THERMALDYNE, LLC
PORT ALLEN PLANT

FEEDSTOCK VARIANCE REQUEST
RESPONSE TO NOD # 1

February 2018

Re: Response to Notice of Deficiency (NOD) #1 for Site-Specific Variance from the Classification as a Solid Waste Pursuant to LAC 33:V.105.O.1.c and 105.O.2.c.
Thermaldyne, LLC
Agency Interest No.: 198467/PER20170004/EPA ID: TBD

FIGURE C 1.2

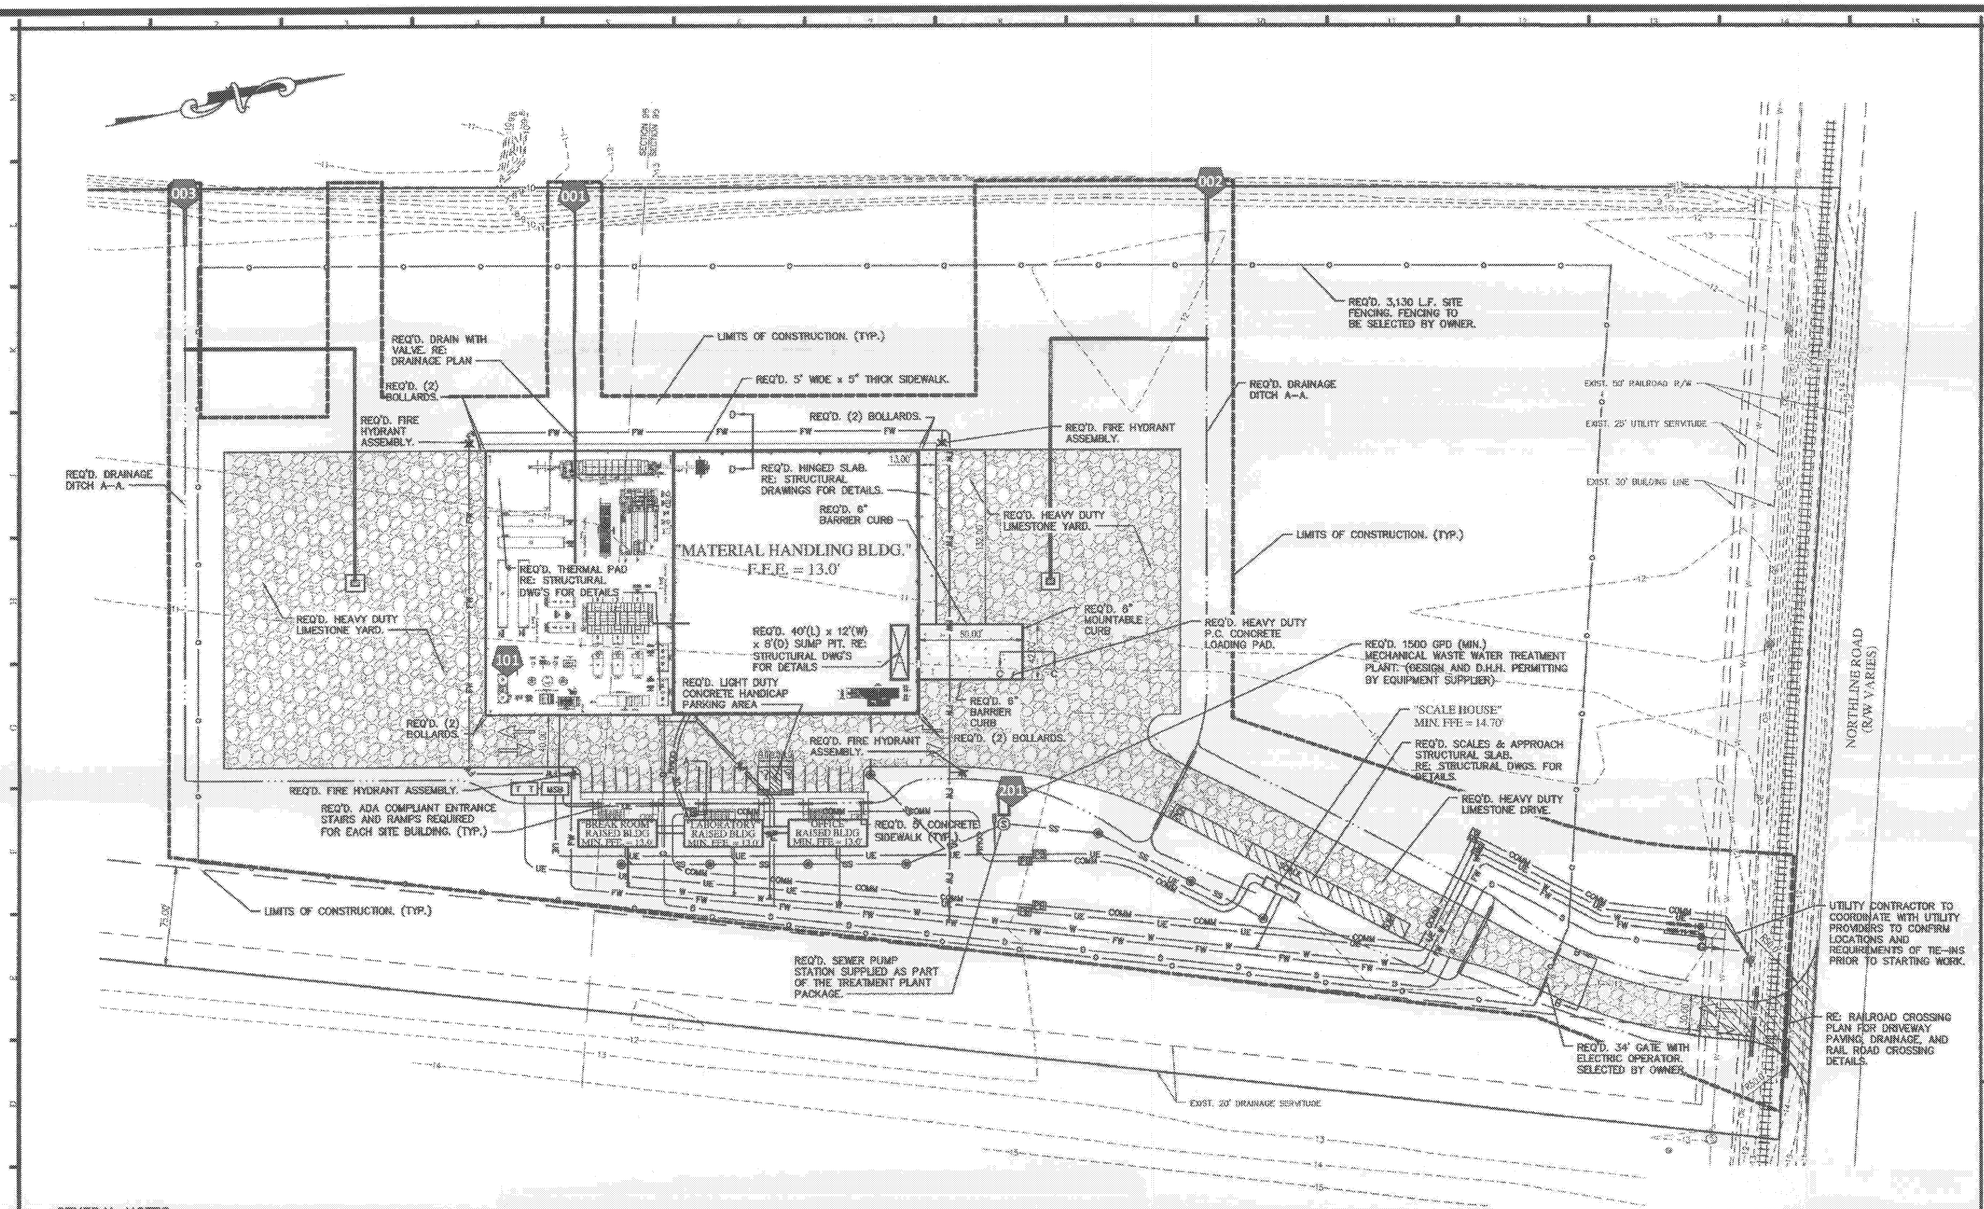
Figure C 1.2 Submit the Figure C 1.2 version of the "Er larged Site Plan" as part of the feedstock variance request under LAC 33:V.105.O.2.b

Figure C 1.2 is provided in Appendix D of this document.
